# UNITED STATES PATENT AND TRADEMARK OFFICE

10/719,438

<b>Office Action Summary</b>	Application No. 10/719,438	Applicant(s) CRAZE, JEAN PAUL	
	Examiner Charles N. Greenhut	Art Unit 3652

Fig. 13

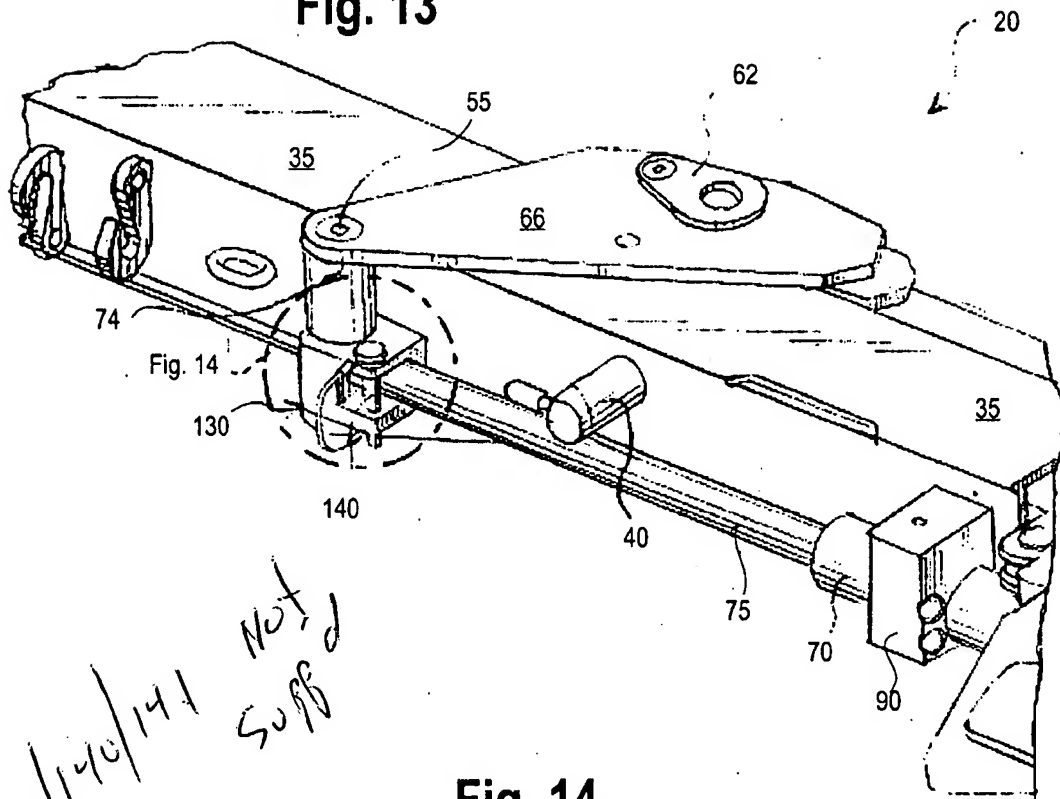
2. Figures 13-16 are objected to as containing new matter as discussed below. Additionally,
  - 2.1. reference numeral 60 has previously been used to reference the plates on adjacent sides of the receiver while “66” is used to reference what appears to be the same feature in figures 13-16. Like features should have the same reference numeral. The record should be clarified with respect to this matter in response to this action.

- 2.2. reference numeral 55, has previously been used to reference the pivot pin, whereas reference numeral 57 has previously been used to reference the cylinder rod connecting pin. In figures 13-16 and the corresponding description, however, “55” appears to be used to denote the cylinder connecting pin. The same reference numeral may not be used to denote different features. The record should be clarified with respect to this matter in response to this action.

1.1. The figures 13-16 showing elements 130, 140 and 141 and corresponding description are not supported by the original disclosure.

2. Applicant argues, by remarks and declaration, that figures 13-16 do not contain new matter because a person of ordinary skill in the art would have understood that the design shown in figures 13-16 had been disclosed in the specification as originally filed. This argument is not persuasive. Firstly, Applicant has supplemented the figures by an amendment to the specification describing the cylinder rod coupling configuration of figures 13-16 as an alternative design. This is evidence that the coupling method shown in figures 13-16 was not contemplated by the original disclosure. Secondly elements 130, 140, and 141 and their corresponding subcomponents are not described anywhere in the specification as originally filed. The paragraph Applicant points to to provide support for this amendment merely states, in relevant part, that, "The cylinder rod connection point may also need to be connected or disconnected as well. For this purpose, the distal ends of each cylinder rod may include an aperture for use in coupling each cylinder rod to a receiver. Alternatively, each cylinder rod may consist of two component rods that are connected to each other, e.g., one may be slidable within the other and they may be attached using a removable locking pin allowing rapid field disassembly." Neither of the contemplated embodiments supports the embodiment shown in figures 13-16. The first requires the cylinder rod to have an aperture (e.g., Fig 4 -75a) which the cylinder rod of figure 14 does not. The second requires the cylinder rod (75) to be composed of two component rods, one slidable within the other, which is not shown in any figures. While it is known in the art that the terminal portion of the rod may take either the form shown in the figures 1-12 embodiment or the 13-16 embodiment, the coupling device itself, generally indicated at 130/140/141 and its attachment to the rod end and the receivers

Do Not -CG  
Enter

Fig. 14

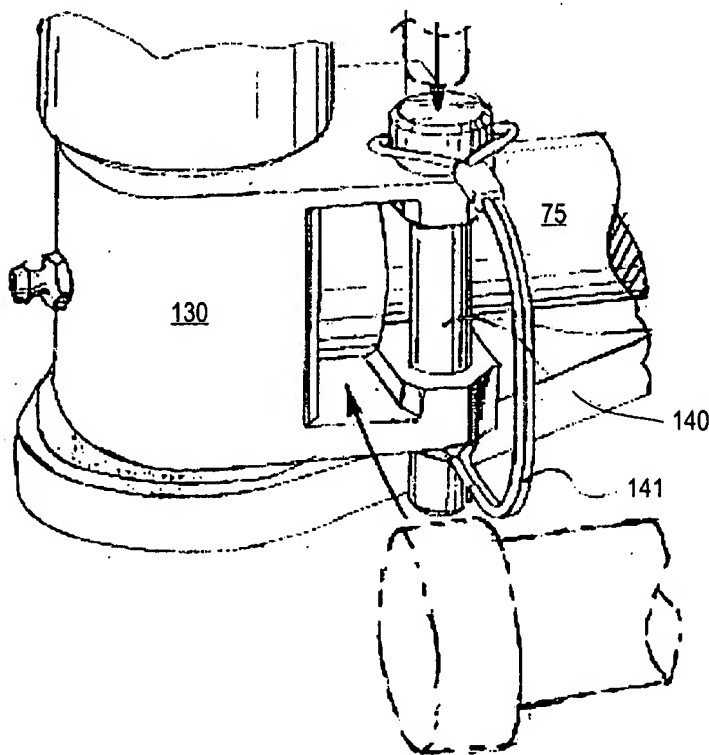
130/140/141 Not  
Subd

Do Not  
Enter NEW DRAWINGS  
-CG
